RE: Addendum No. 1 to the Bidding Documents for:

Good Samaritan Society
Millard 400 Wing Renovation
Millard, Nebraska
Schemmer Project No. 06107.001

SHEET NO: SDM-1

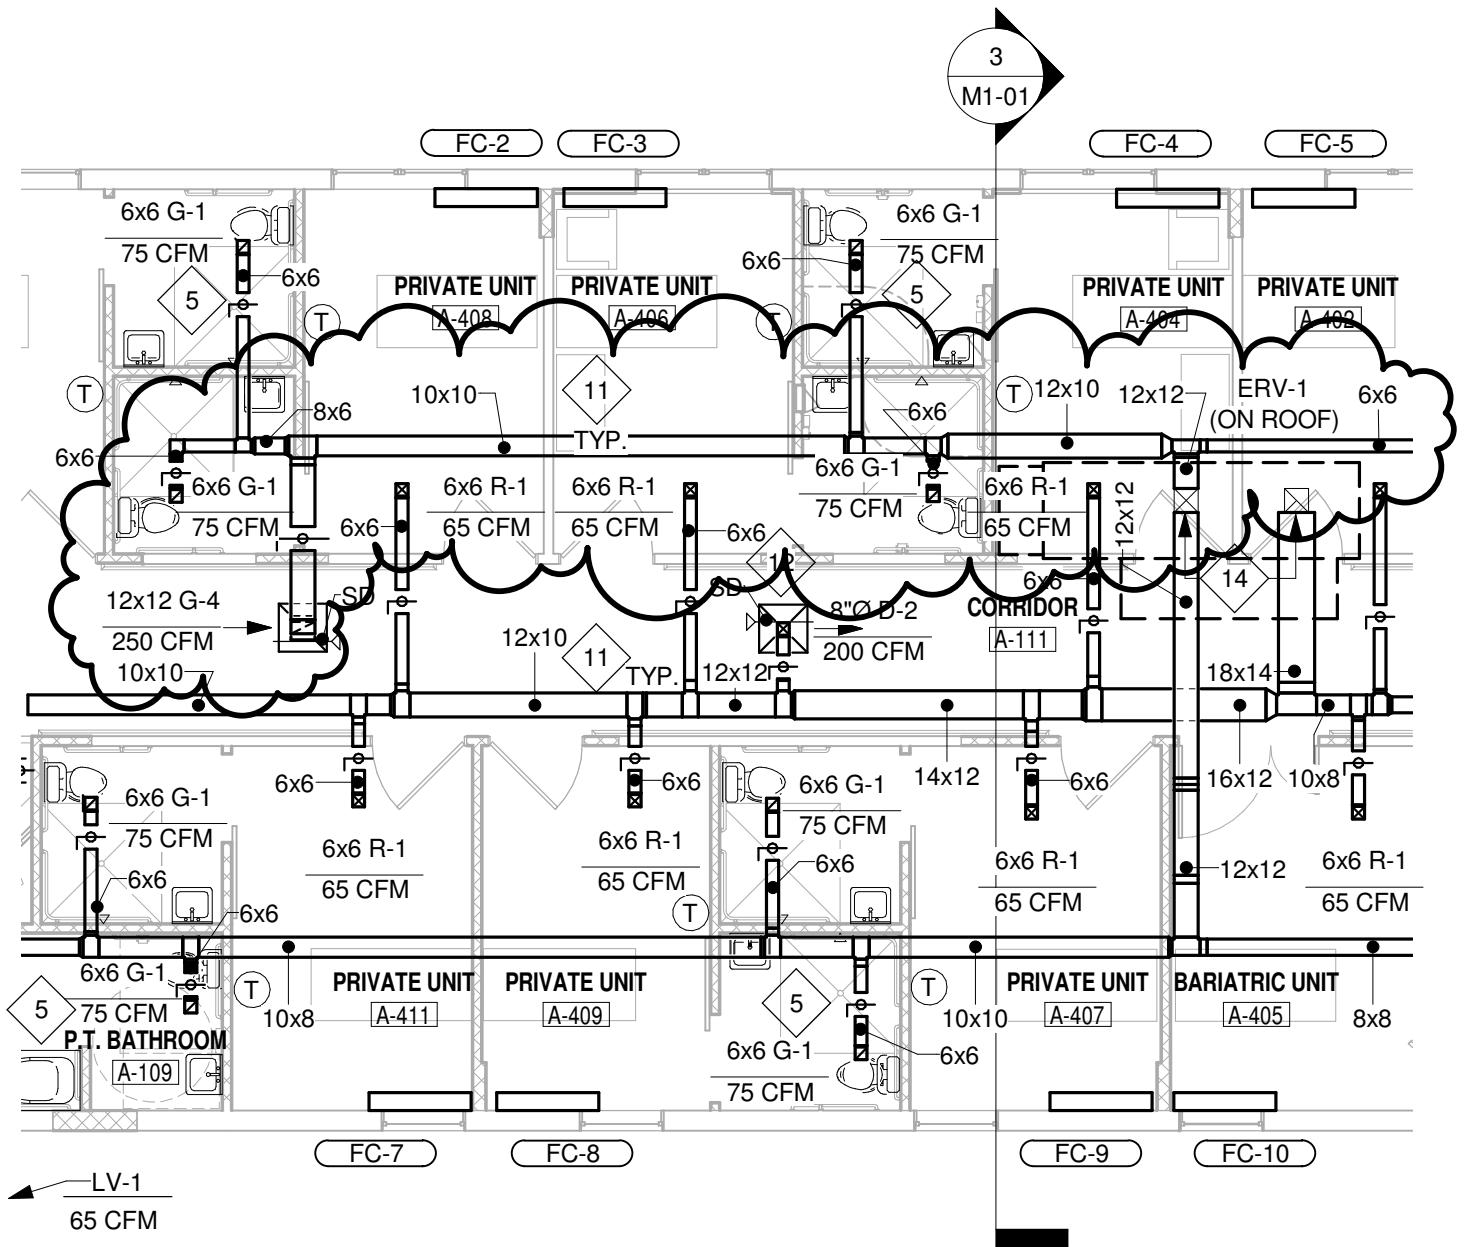
Item No. DM-3, Sheet M1-01:

Refer to supplemental drawing SDM-1 for return grille G-4 added in Corridor A-111 and modified return duct sizes from this grille to ERV-1 on roof.

SHEET NO: SDM-3

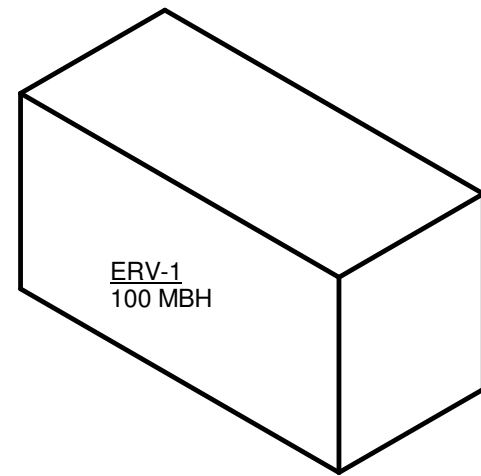
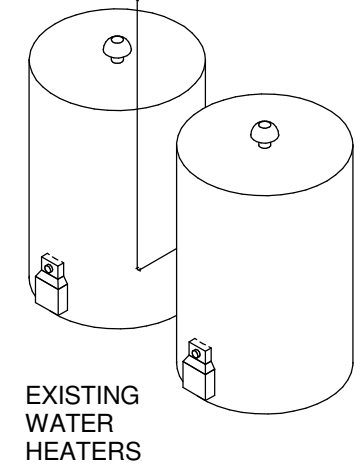
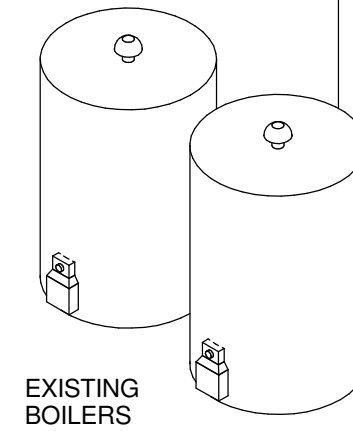
Item No. DM-7, Sheet P2-01:

See attached drawing SDM-3 for gas piping riser diagram and sizing. Gas piping sizing on SDM-3 supersedes gas pipe sizing shown on previous drawings.

INSTALL 1" GAS PIPING FROM
ERV-1 TO EXISTING
1" G ON ROOF. EXTEND
PIPING AS REQUIRED.

1 1/2" GAS
PIPING IN
ATTIC
